PLANNING COMMISSION MEETING

**WHITE LAKE TOWNSHIP
PLANNING COMMISSION
SEPTEMBER 17, 2026**

RE: Ginko Self Storage -Final Site Plan/Final Engineering Plan Review-4th Review
~~Stormwater Maintenance Agreement Review-1st Review~~

Revised Final Site Plan Review for Special Land Use for White Lake Charter Township, Michigan

RED LINED
PLAN SHEET
TO
ACCOMPANY
REVIEW.04

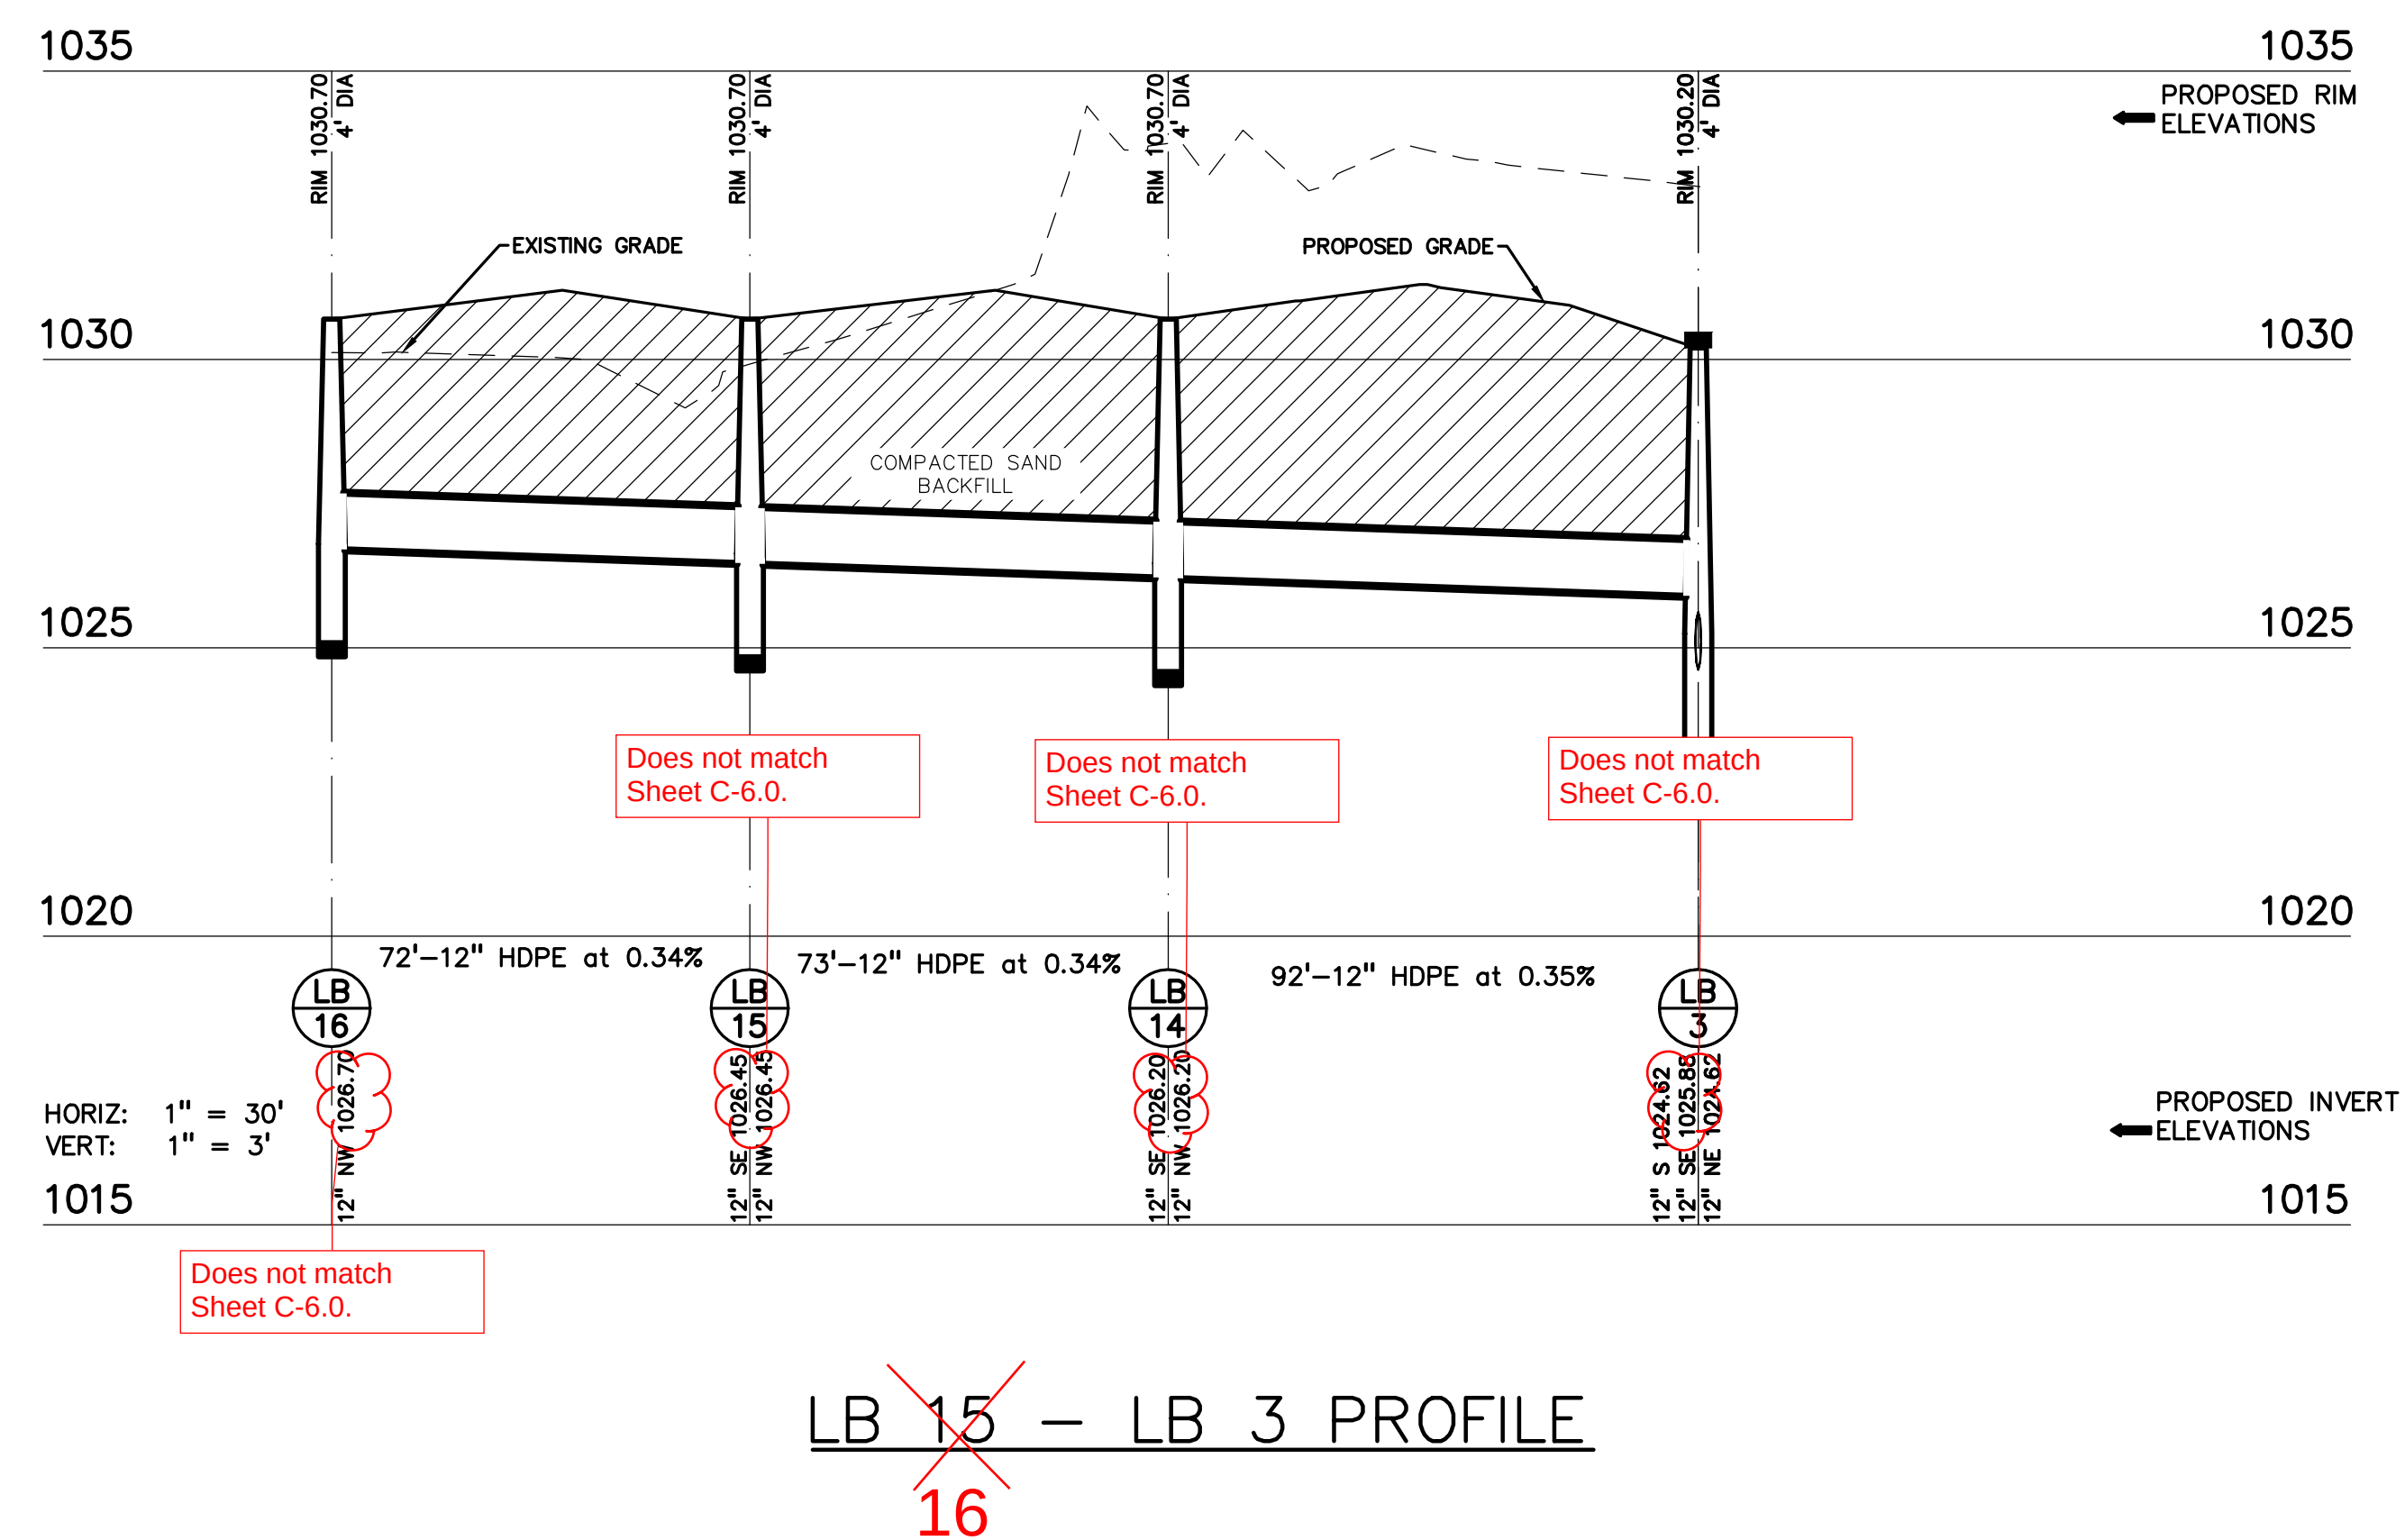
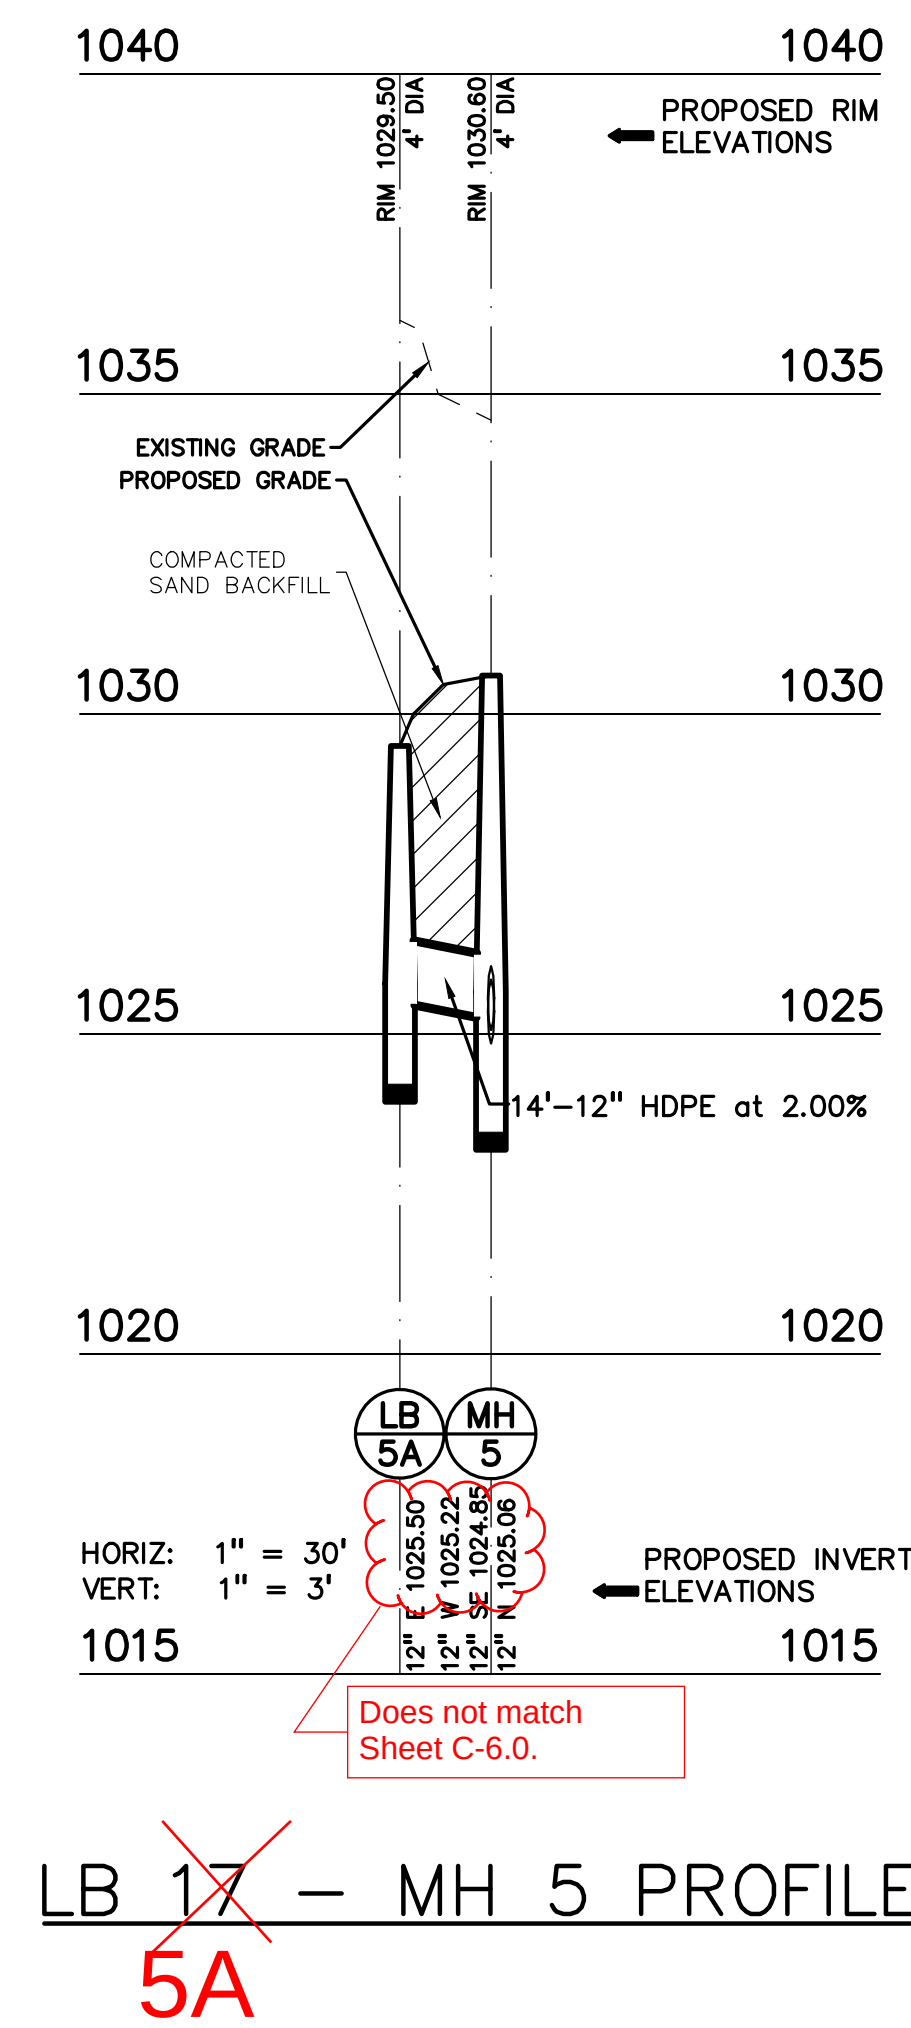
3. Sheet C-7.0- It appears that profiles were not updated based on revised storm sewer structure rim and invert elevations. We have attached a red lined copy of this sheet.

DRAWING TITLE
TOPOGRAPHIC SURVEY

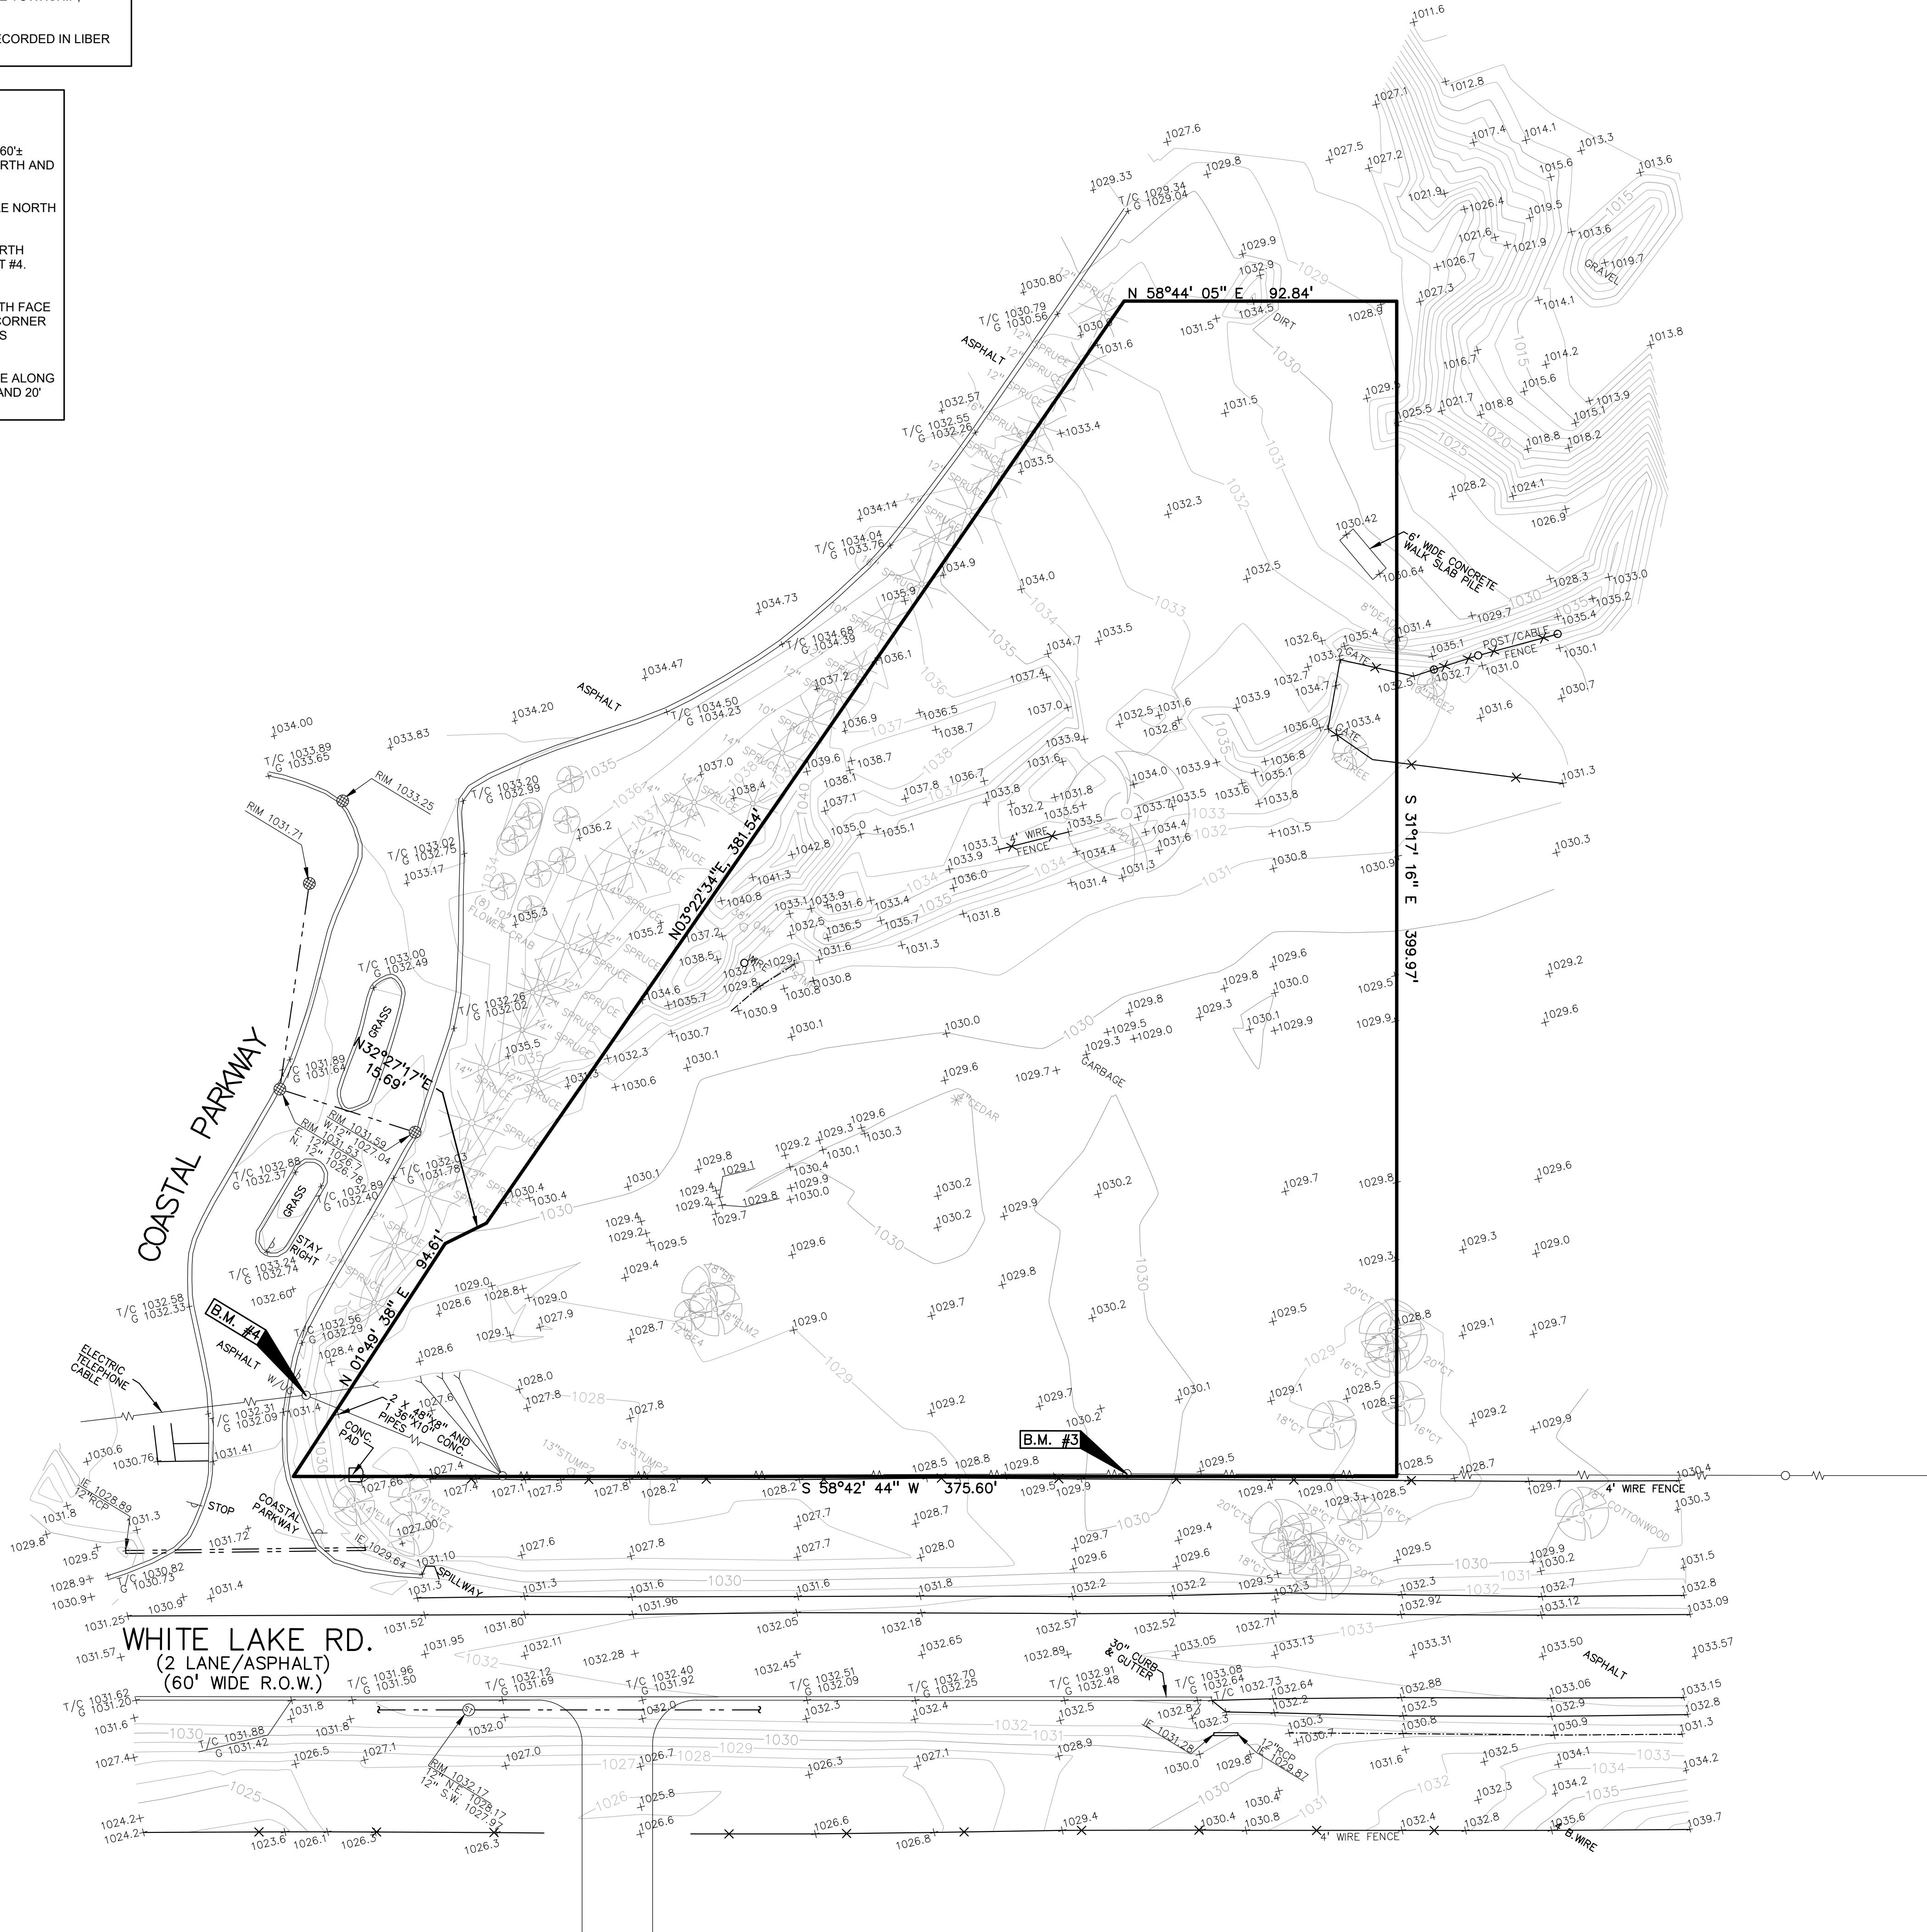
Topography: Sheet C-1.0 shows existing site topography. The southern portion of the lot is relatively flat. A steep ridge exists along the mid-western border of the site. Sheet C-4.0 outlines proposed site grading. Grading is proposed throughout the central portions of the site to accommodate level surfaces for asphalt and structures. Grading along the western edge is for the purpose of smoothing in preparation for onsite septic and proposed landscaping.
